# UNITED STATES PATENT AND TRADEMARK OFFICE

<b>Office Action Summary</b>	<b>Application No.</b> 10/519,169	<b>Applicant(s)</b> KIKUKAWA ET AL.	
	<b>Examiner</b> GERARD T. HIGGINS	<b>Art Unit</b> 1794

## **DETAILED ACTION**

Fig. 1. Cross section of a new disk. Silver oxide film is used as the readout layer, instead of an Sb film.

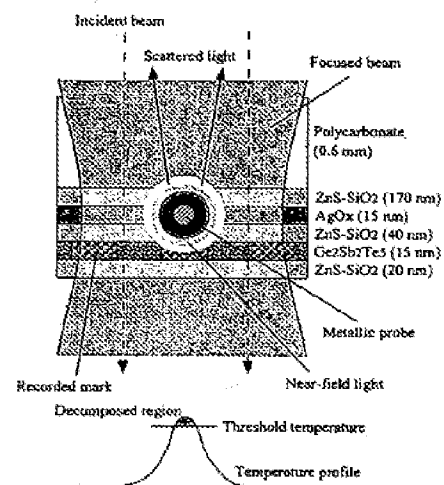
A Near-Field Recording and Readout Technology Using a Metallic Probe in an Optical Disk sets forth the optical disk structure of Figure 1, which is equivalent to applicants' claims 1-6. It includes recording marks with a recording length shorter than

$0.37\lambda / NA$ , wherein marks of less than 100 nm using a laser with a NA of 0.6 and  $\lambda = 635$  nm [i.e.  $(0.37 * 635)/(0.6)$ ], and it also operates by decomposition of noble metal oxides, which would intrinsically form oxygen gas that would deform the metal oxide layer; however, it fails to disclose a recording medium that undergoes irreversible changes in the noble metal oxide layer when irradiated with light.
